REGULAR MEETING AGENDA

Project Name: White Water Car Wash

**Staff Report
White Water Car Wash
2675 Washtenaw Avenue
Preliminary Site Plan and Special Land Use**

Preliminary Site Plan and Special Use Review For Ypsilanti Township, Michigan

PRE-DEVELOPMENT DRAINAGE AREA MAP

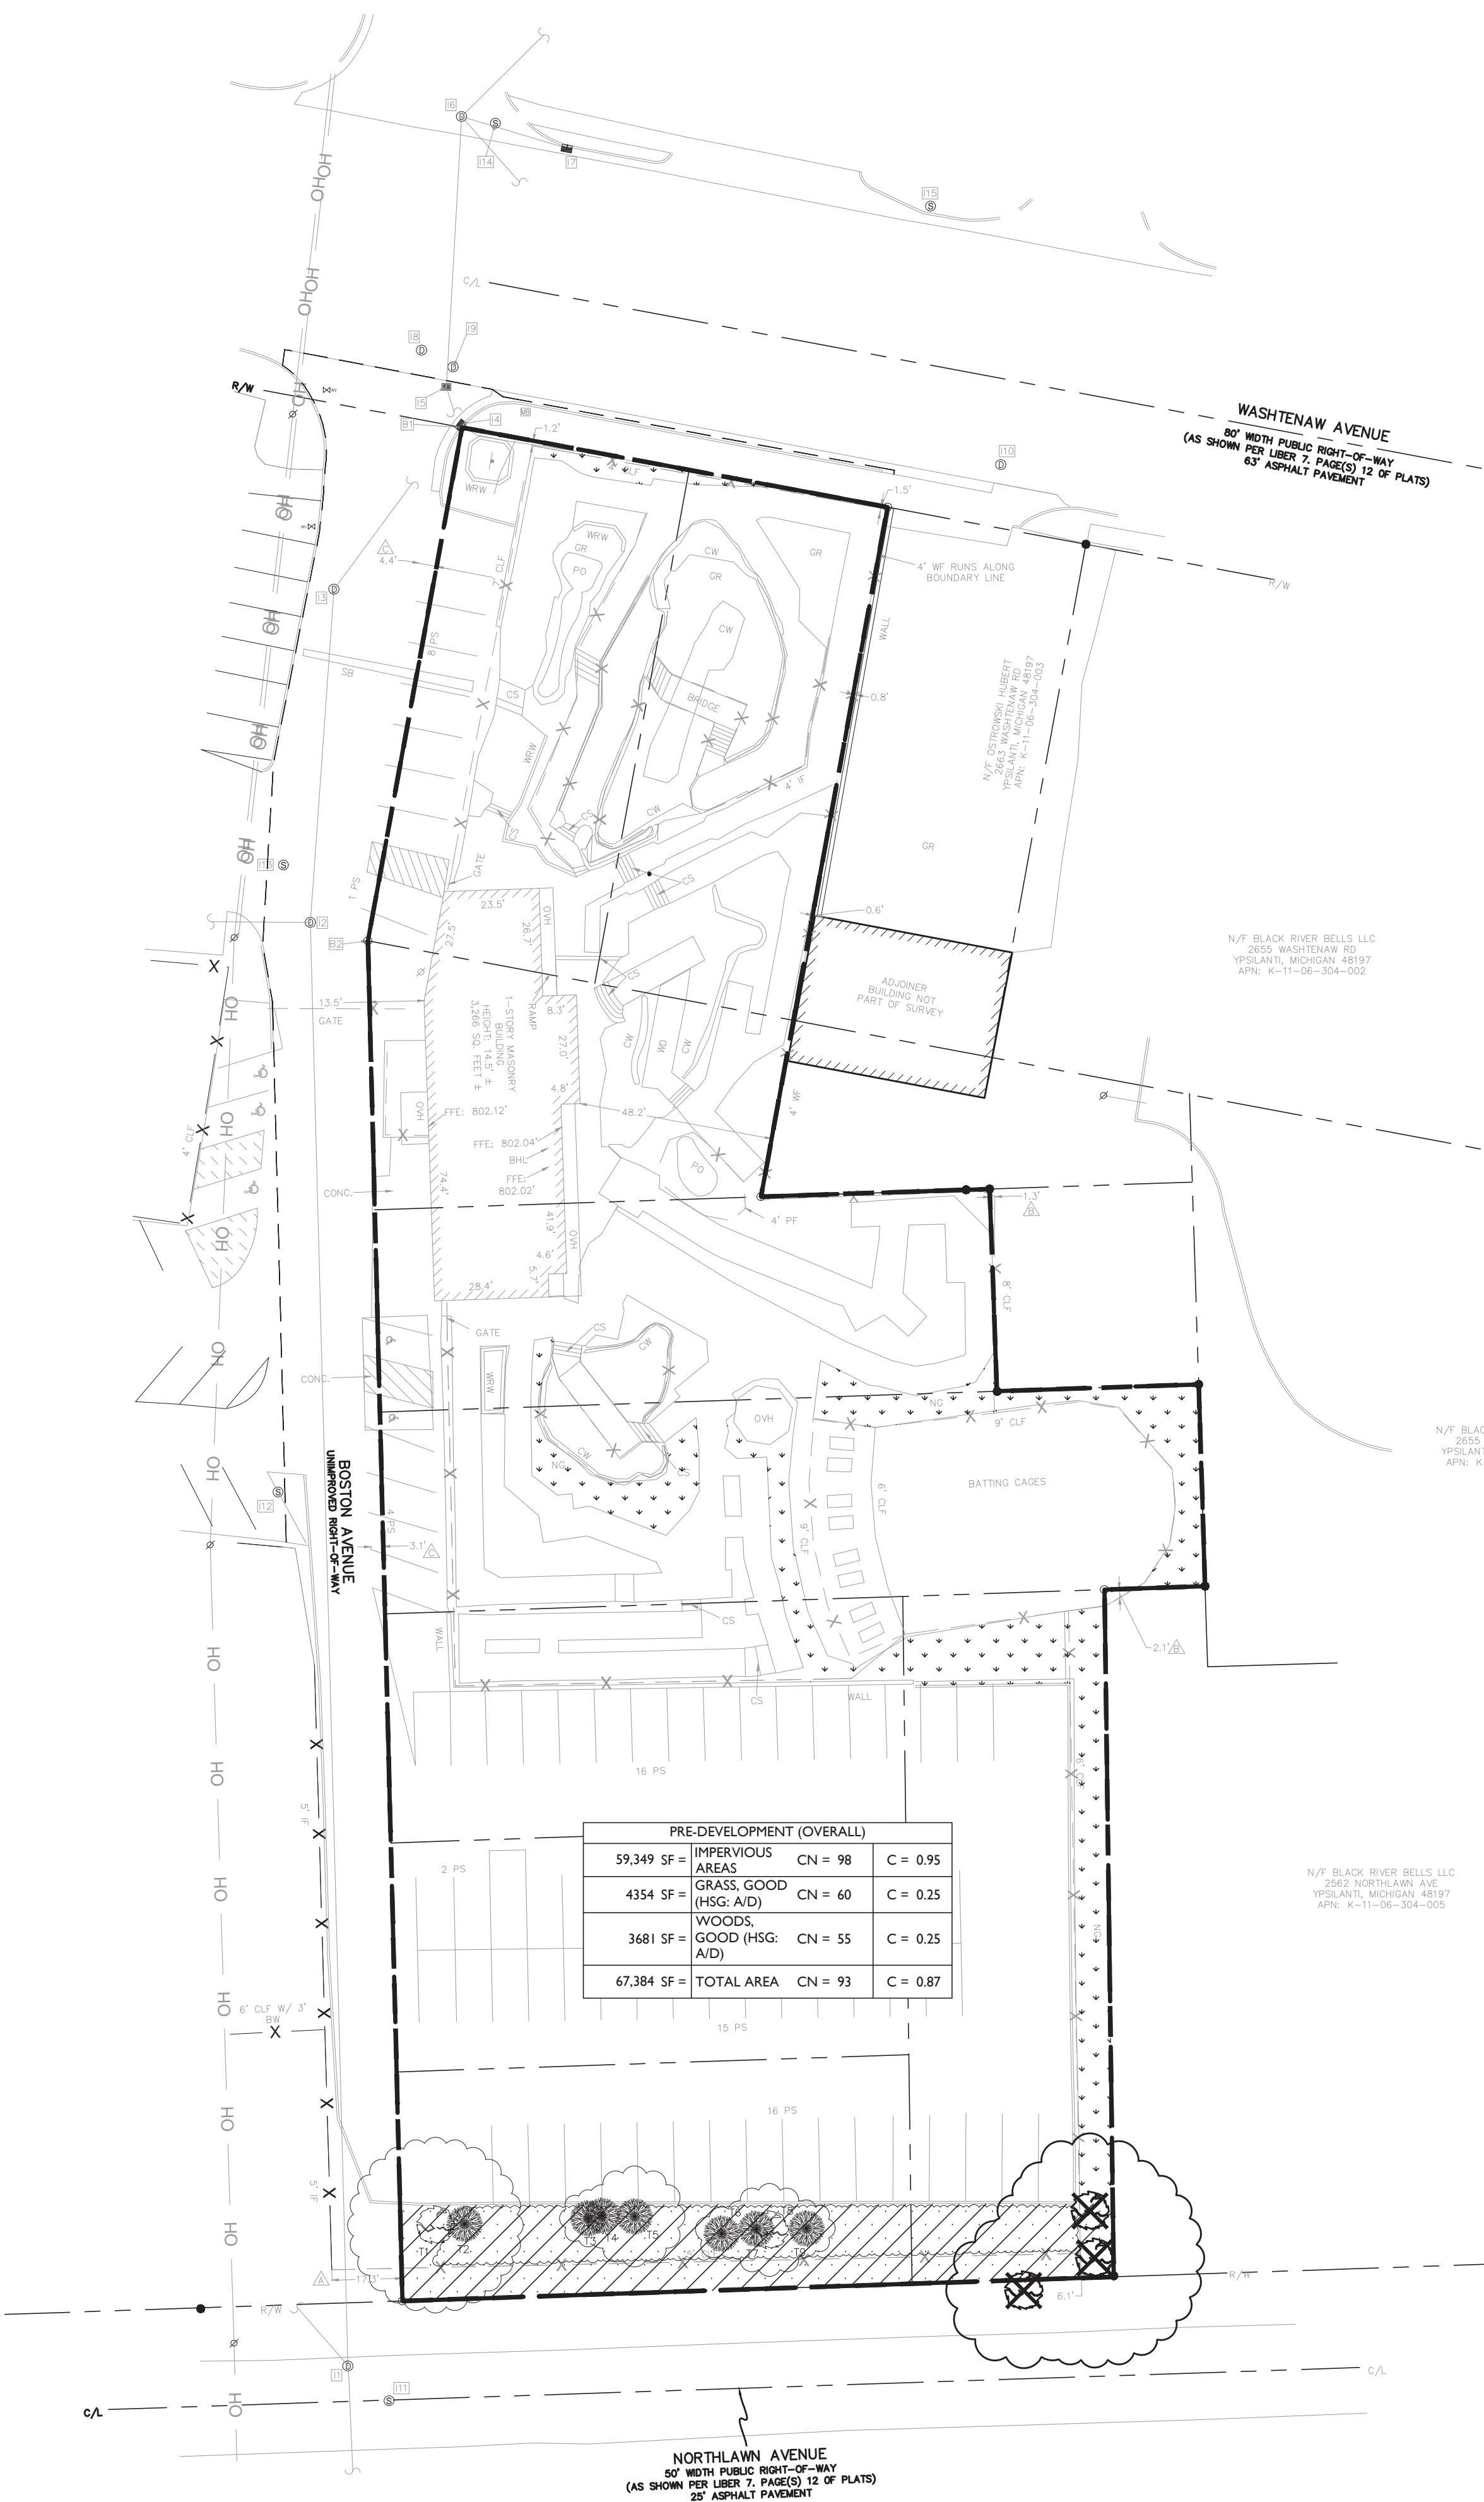
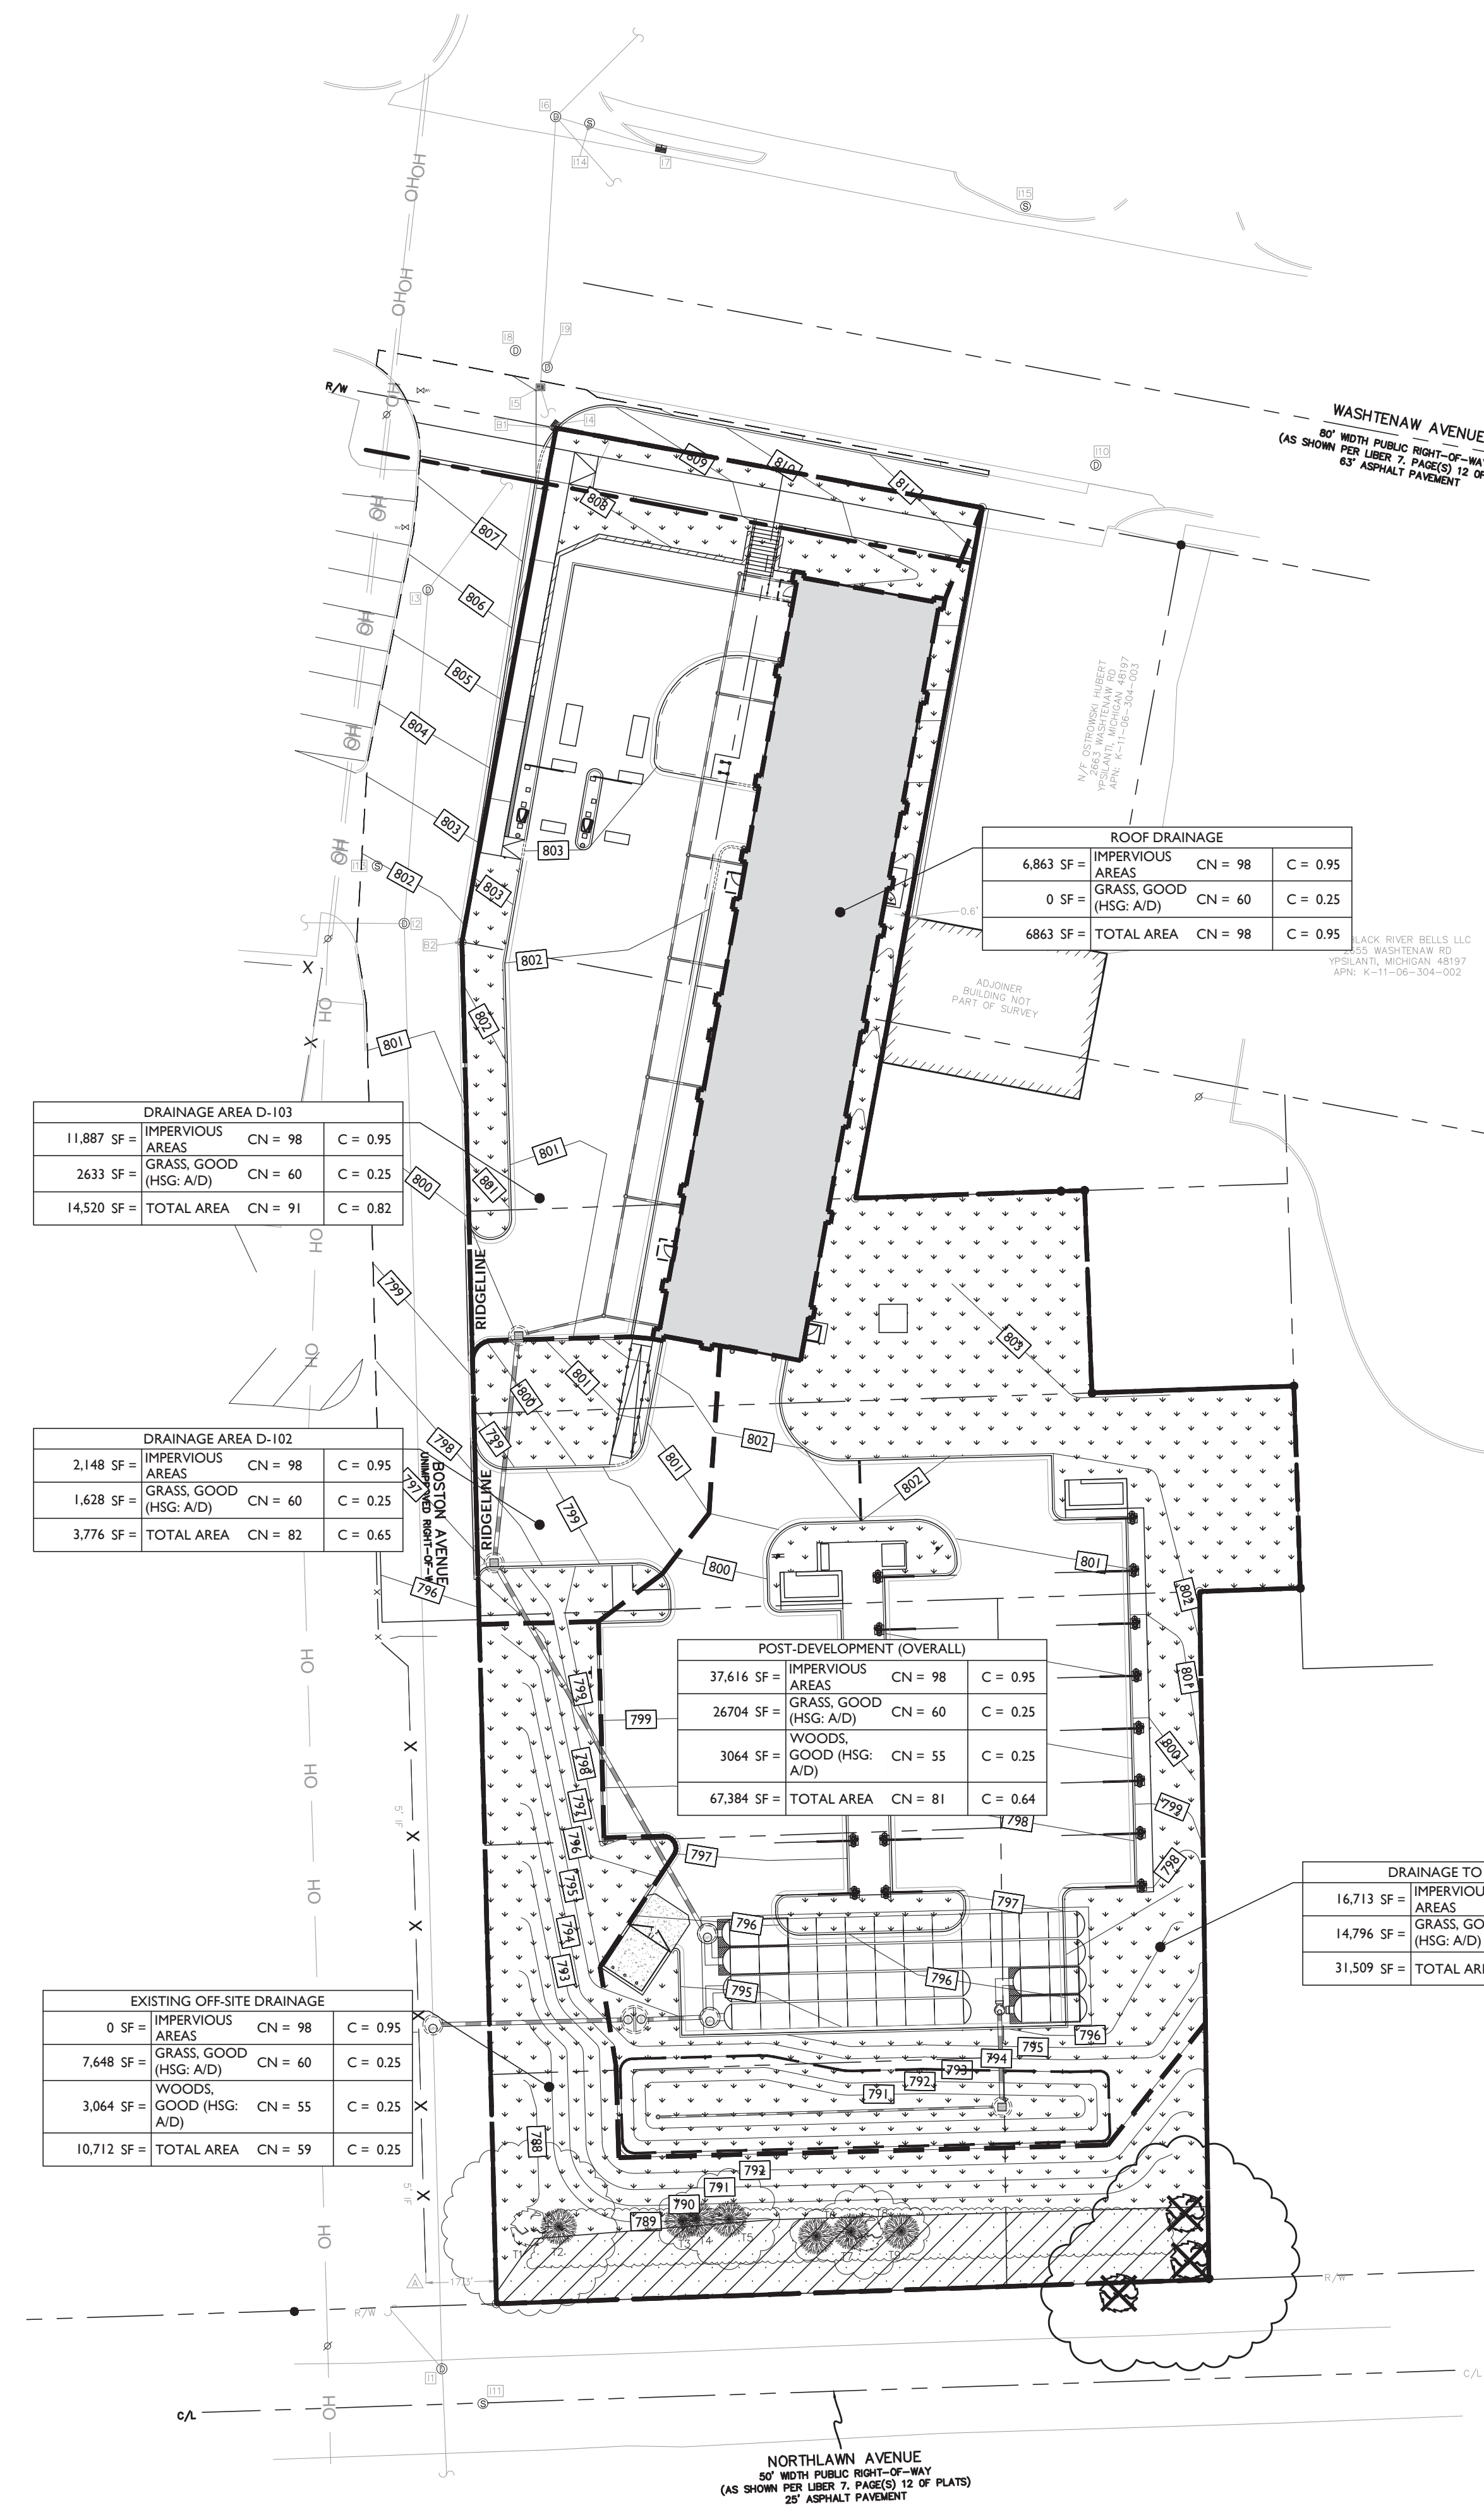
9. The applicant shall adjust the Drainage Area callouts (Sheet C-6) as one of them is currently cutoff.
10. The applicant shall verify the ground/rim elevation of Structure EX-1 as there appears to be a discrepancy between the profile view (Sheet C-17) and the plan view (Sheet C-5).

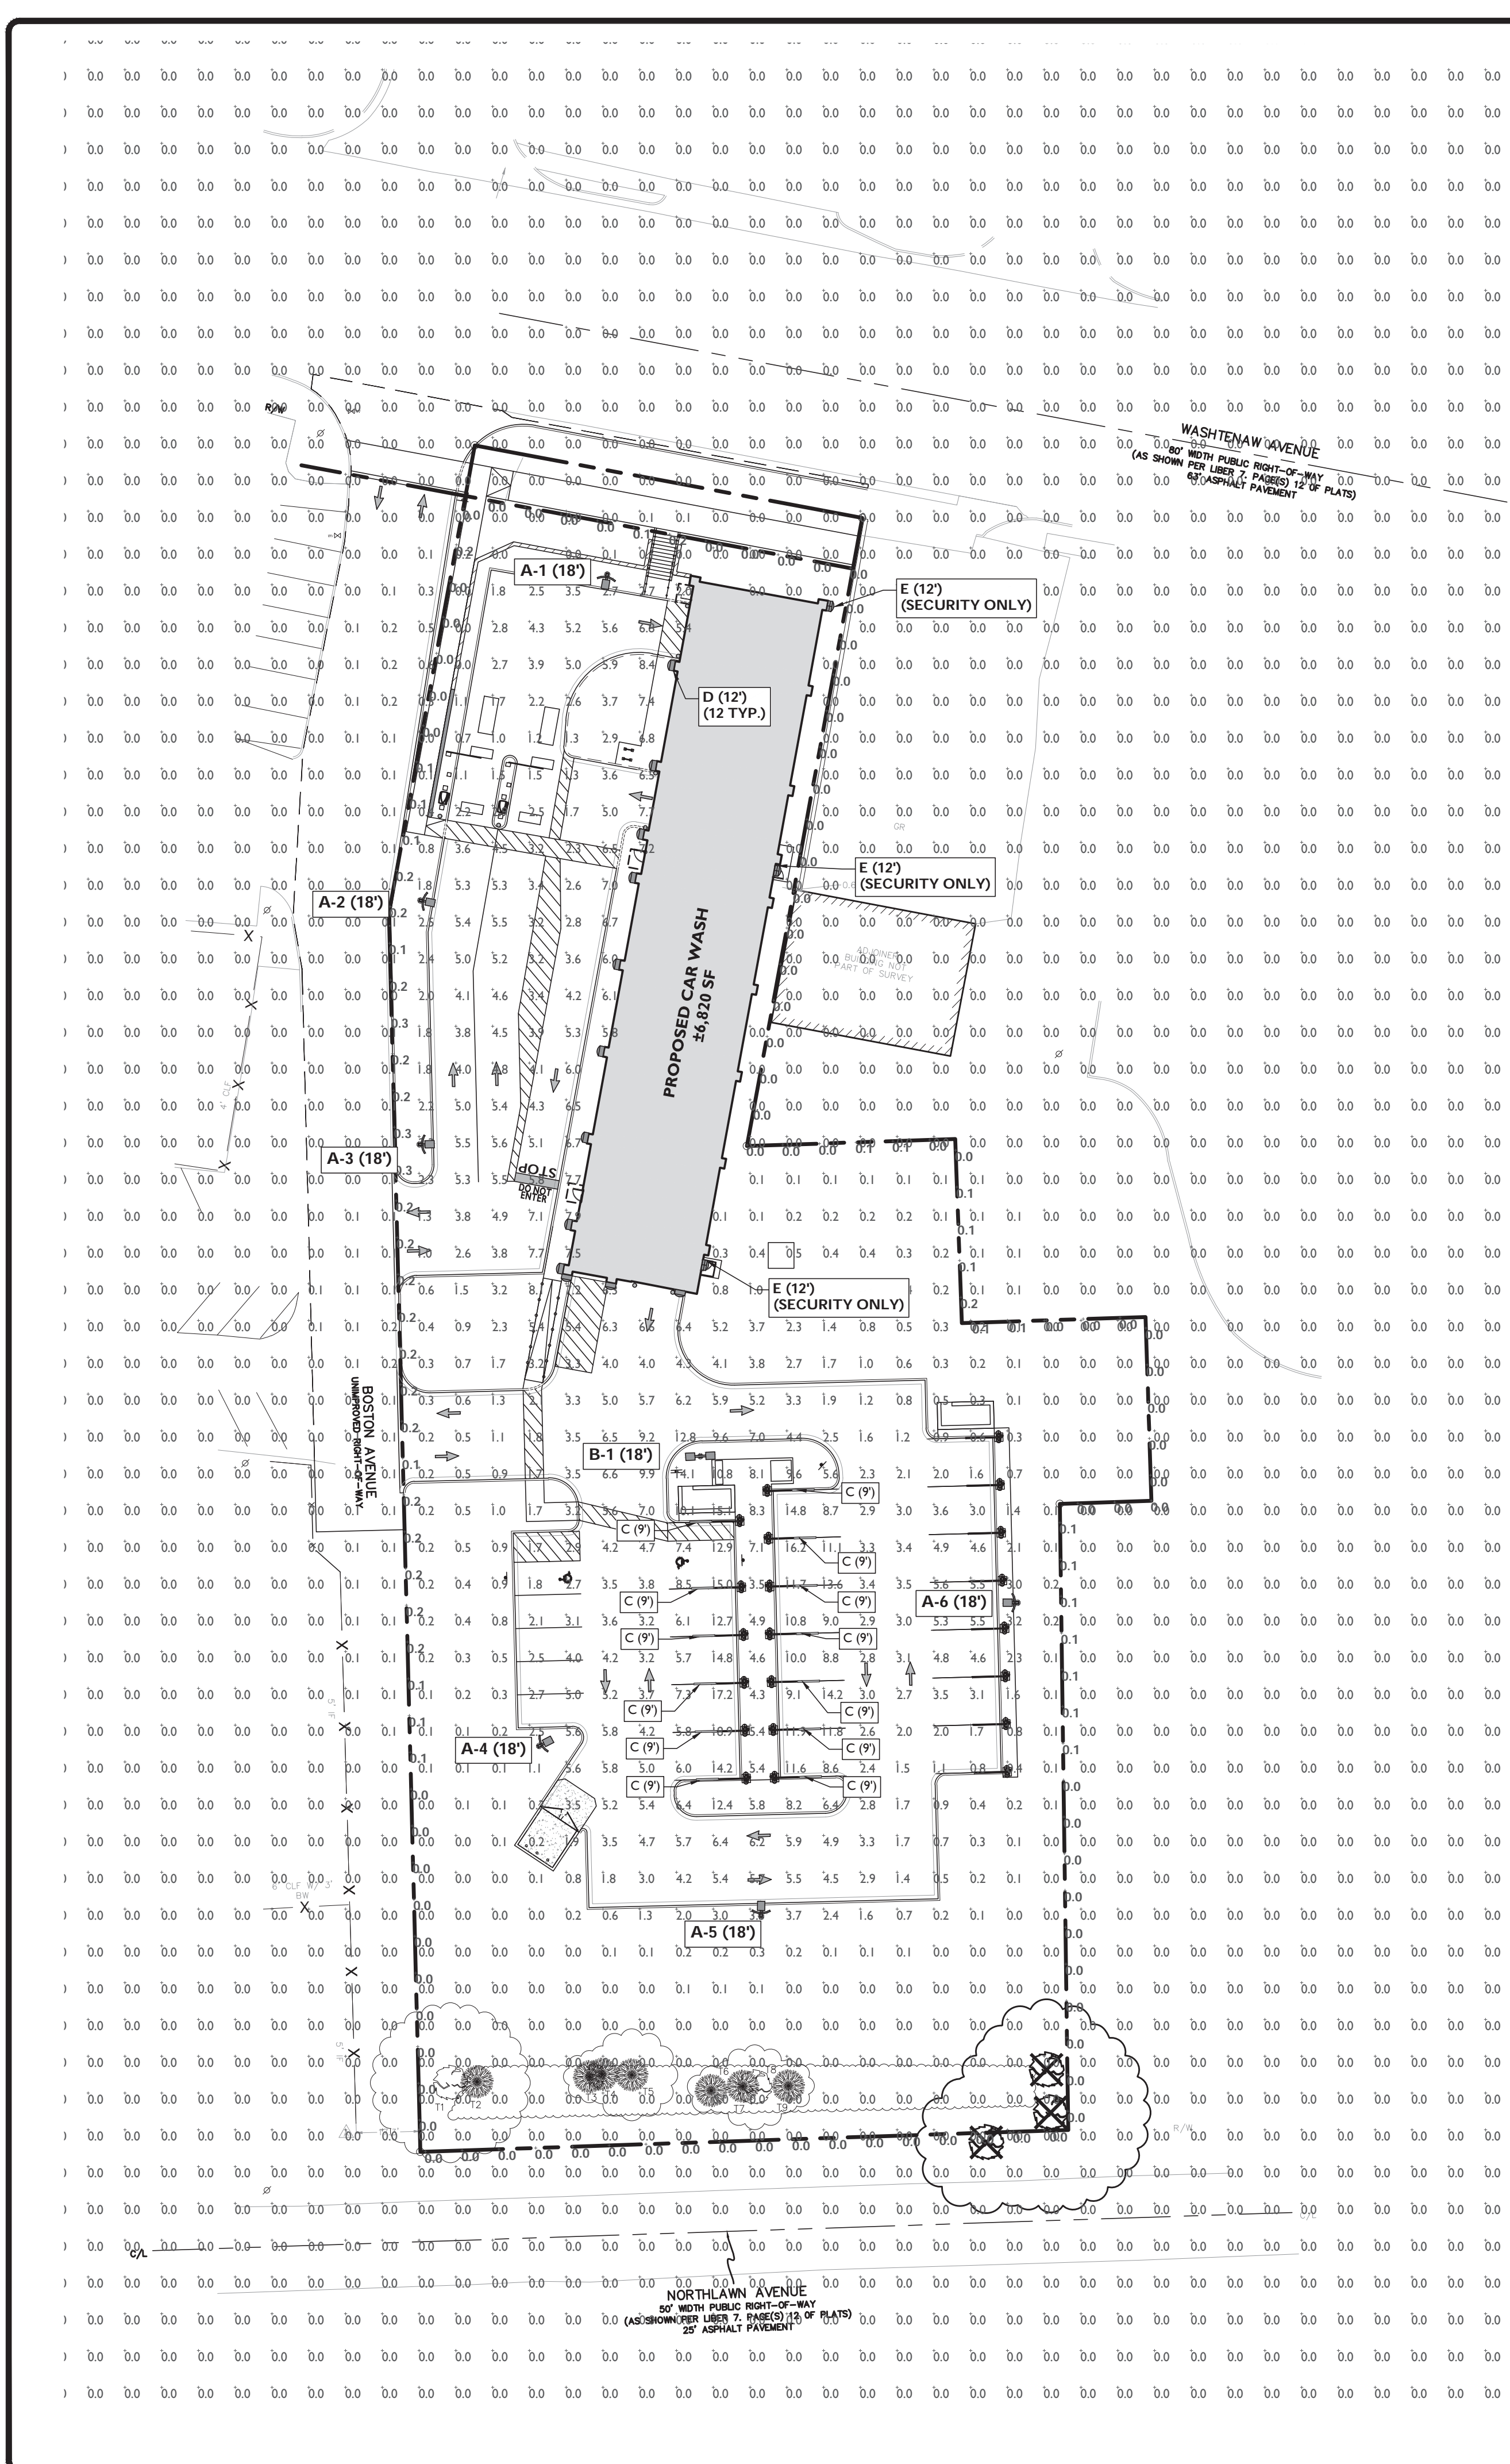
Items to be Addressed: 1) Add 13 more shrubs to plans along Boston Ave. frontage; or Planning Commission to consider waiving/modifying this standard due to site constraints. 2) Planning Commission to consider proposed modification of screening between land uses (or no narrow evergreens). 3) Applicant to consider native alternative to English Laurel.

18. A long-term stormwater maintenance plan, including budget and responsible party, should be designed and included with the plan set.
19. The bioretention basin area shown on the landscape plan (sheet C-9) was hatched up to what appeared to be Elevation 793 feet. The hatched area should be expanded to include both the basin and buffer areas.

Stonefield Response: 13 additional shrubs have been added along Boston Avenue to the Landscaping Plan. See Sheet C-9.
